401 Summit Court
Russell Bate
Tentative Map

M-79-18
9/12/79

REPORT TO: The Planning Commission
FROM: Lee E. Bowman, Planning Director
SUBJECT: Subdivision Application M-79-18
3-lot subdivision
APPLICANT: Russell Bate
LOCATION: Surmont Court
EXHIBITS: A. Tentative map, received December 7, 1979 (previously distributed).
B. Staff report, dated January 4, 1980 (previously distributed).

REPORT TO: The Planning Commission
FROM: The Development Review Committee
SUBJECT: Subdivision Application M-79-18
APPLICANT: Russell Rite
LOCATION: 401 Summit Court
ZONE: HR-2½ (Hillside Residential - 2½-10 acres per dwelling unit)
FINDINGS: As required by the Map Act
ACTION: The decision of the Planning Commission is final unless
appealed within 15 days.

TENTATIVE MAP
for RUSSELL BATE

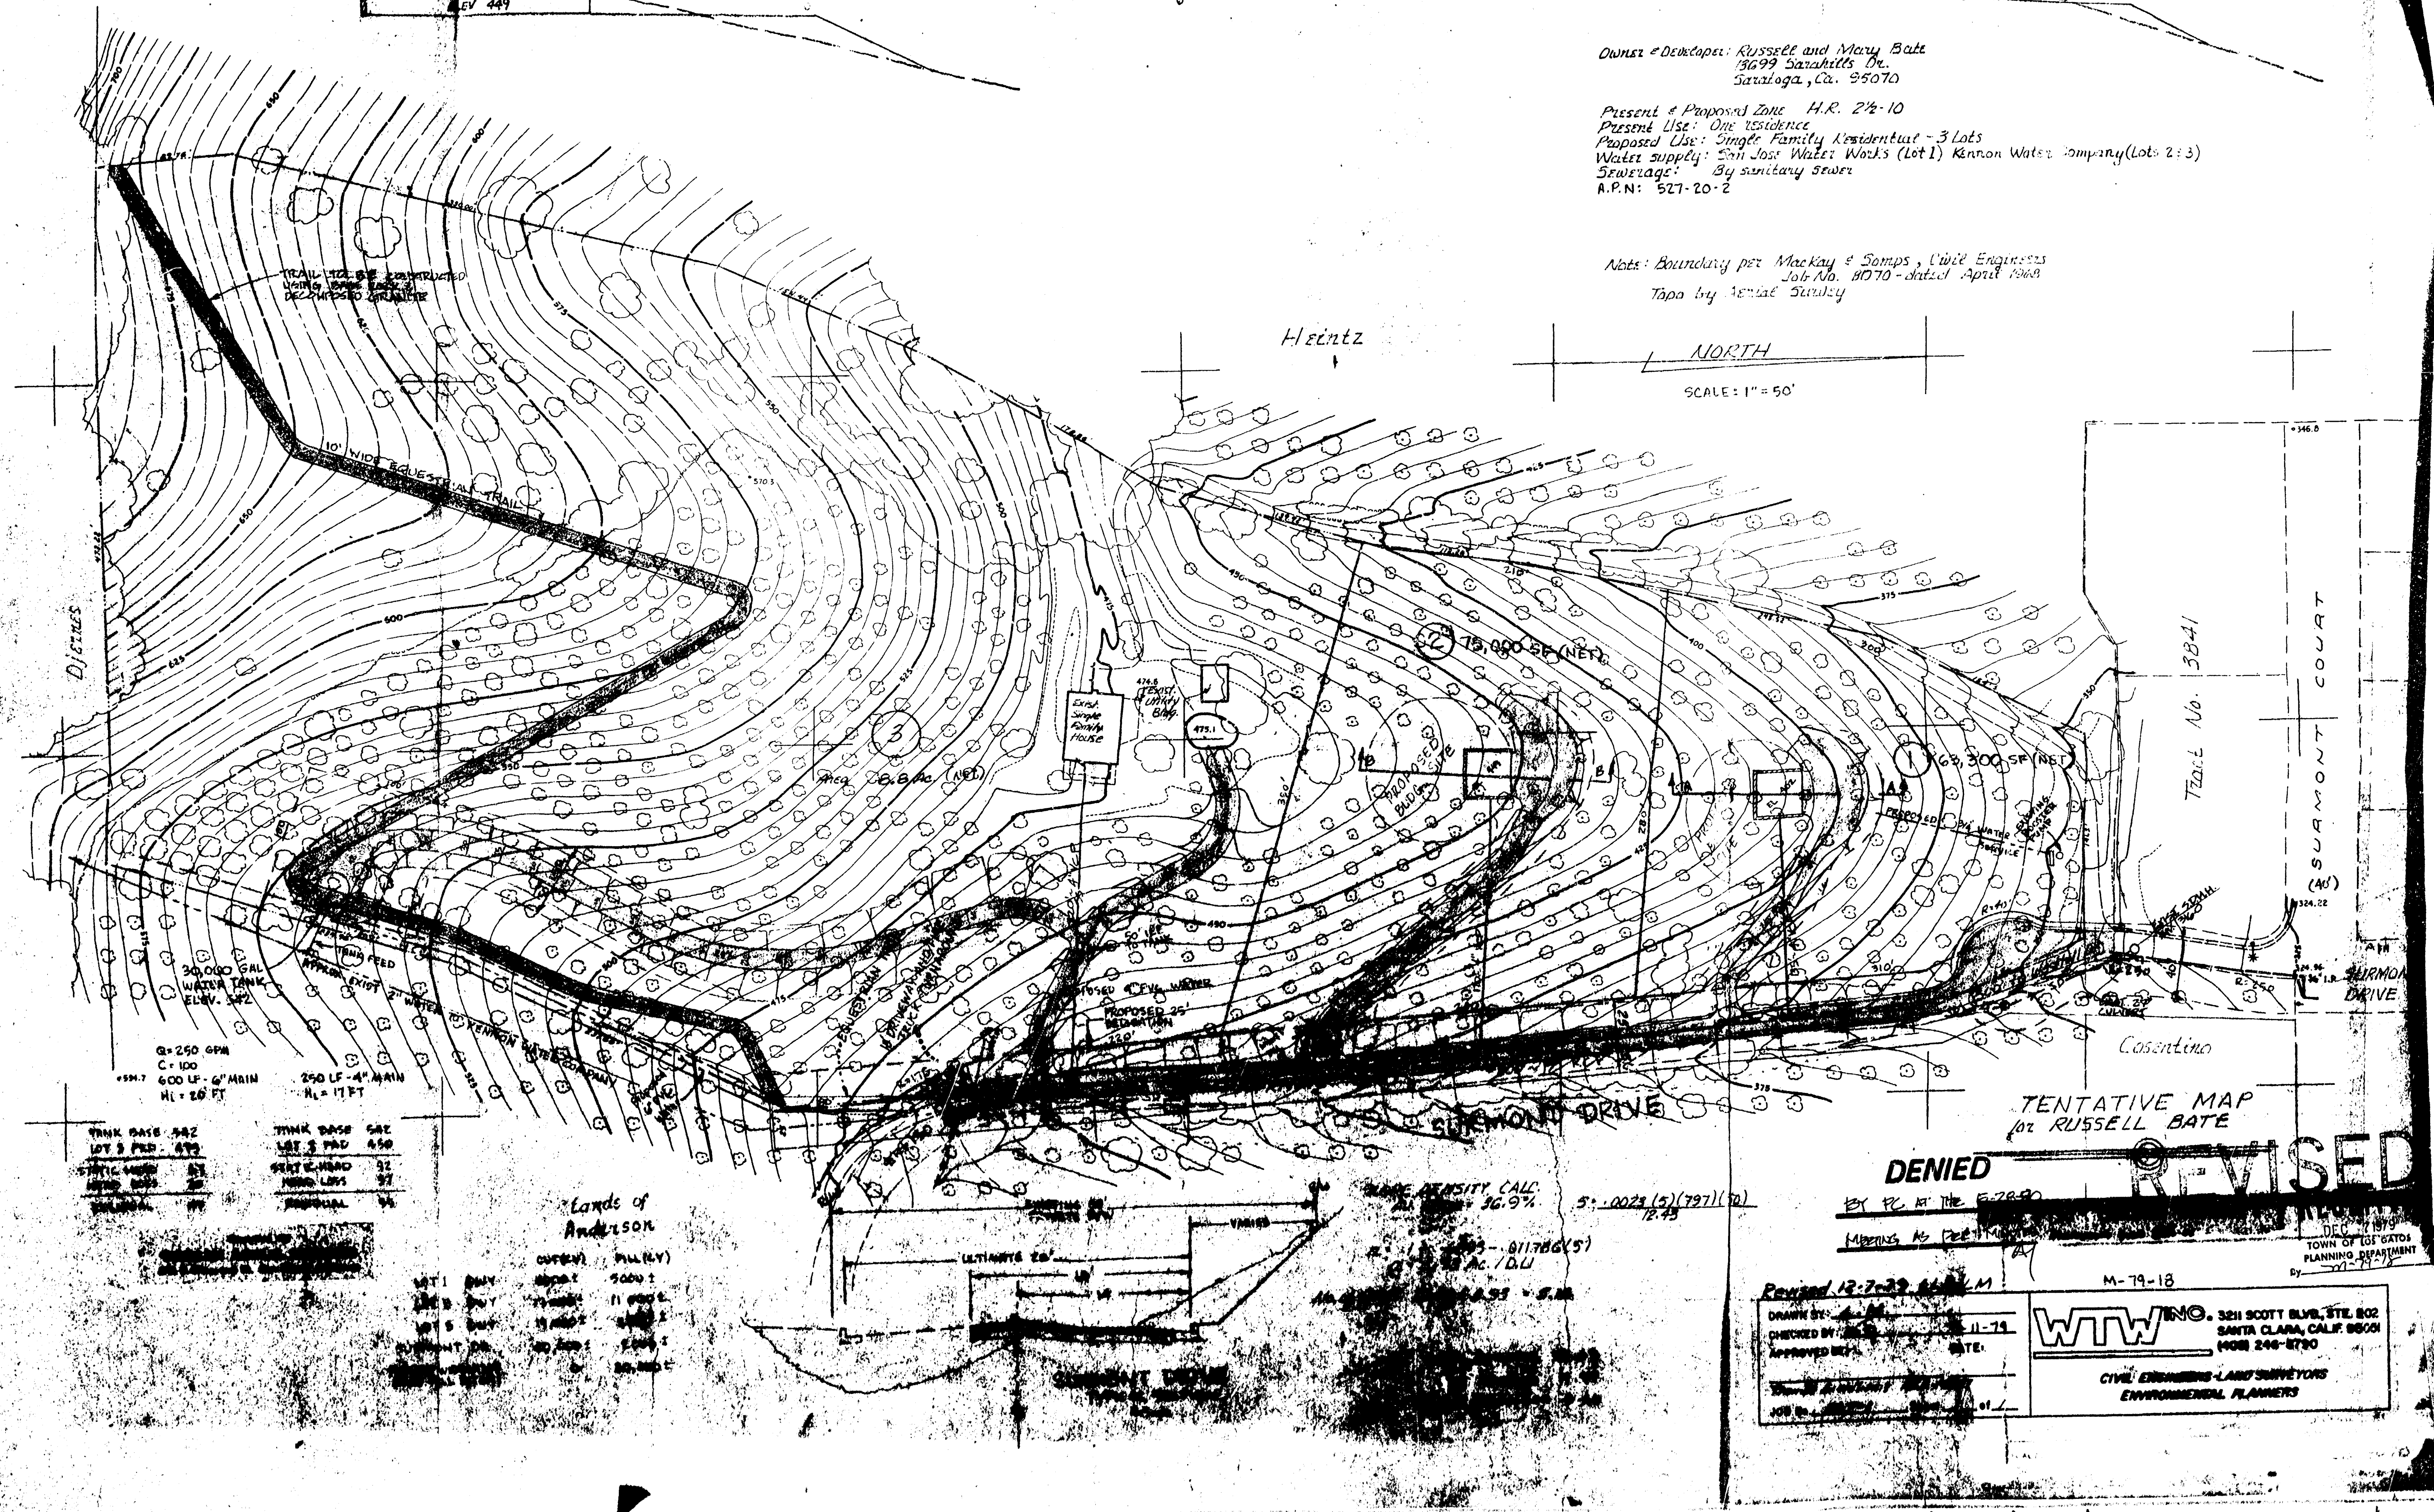
1. The applicant is proposing to divide approximately 12.43 acres into 3 lots, which is the maximum allowed under current development standards.
2. Lot #1 will contain 63,300 square feet of net land area, and has no existing structures on the site. A conceptual site development plan has been indicated on the Tentative Map.

Lot #2 will have 75,000 sq. ft. of net land area and is also currently vacant, with a conceptual site development plan submitted.

Lot #3 will contain 8.8 net acres, and has an existing single family residence on the site. However, the utility building shown on the Tentative Map is actually a second residence. Therefore, no land division can be made until provisions have been made for removal of one of the residential uses.

3. The major problem with the project continues to be the water supply. The upper portion of the Das property, the adjacent Anderson property and this parcel are served, or proposed to be served, with individual pump systems. The proposed water system for this subdivision consists of the installation

of a 30,000 gallon storage tank located on the southeast corner of Lot #3 to be fed by a private 2-inch water line (owned by the Kennon Water Co.). The line apparently runs between Blossom Hill Road and Shannon Road. Lots #2 and #3 are proposed to be gravity fed by new 6-inch and 4-inch water mains from the storage tank. Lot #1 is proposed to be served from an existing booster pump located at the northerly side of the lot. Three-quarter inch water services are proposed for each of the three lots. Staff feels that these should be increased to at least 1-inch services. It is recommended that development not be allowed to use the private water system proposed. The Town's policy is for all new development to be served by a public water system as opposed to the proliferation of small private systems. If this parcel is allowed to develop to its ultimate density without public water, there will be fewer participants and lesser possibility of a joint project to bring in public utility water for this area.

4. The grades of the driveways to the three lots are shown on the revised tentative map to be 15%. They will require substantial grading with up to 6-foot cuts indicated. The driveways are over 150 feet long, so will require one turnout each for emergency vehicles. The revised map shows fire truck turnarounds which will require extensive fill slopes (22 feet high for Lot #1 and 14 feet high for Lot #2).

5. The revised Tentative Map shows a concept plan for storm sewer installation of a 15-inch RCP on the roadway connected to an existing storm drain in Summit Drive.

6. The revised Tentative Map shows a concept plan for sanitary sewer with a 6-inch main proposed to be installed for the full length of the roadway. The laterals serving the three lots are also shown.

7. Building site grading indicates tri-level homes proposed for Lots #1 and #2. Grading for garage pads will require a cut of 11 feet for Lot #1 and a cut of 8 feet for Lot #2. Cuts are to be retained with foundation walls.

8. The revised map does not indicate how many trees will be required to be removed or what species the trees are.

9. Grades on the equestrian trail, which is now shown to lead up to the southwest corner of lot #3, range from 7 to 24%, which may be too steep for horses.

11. Section 27-64 of the Subdivision Ordinance states that cul-de-sacs shall not exceed 500 feet in length. Summont Drive is currently 500 feet, and the Tentative Map shows an extension beyond this maximum to serve the proposed lots. A cul-de-sac, however, may be increased by action of the advisory body upon finding that alternative solutions to emergency access, utility services, and circulation problems are satisfactory.
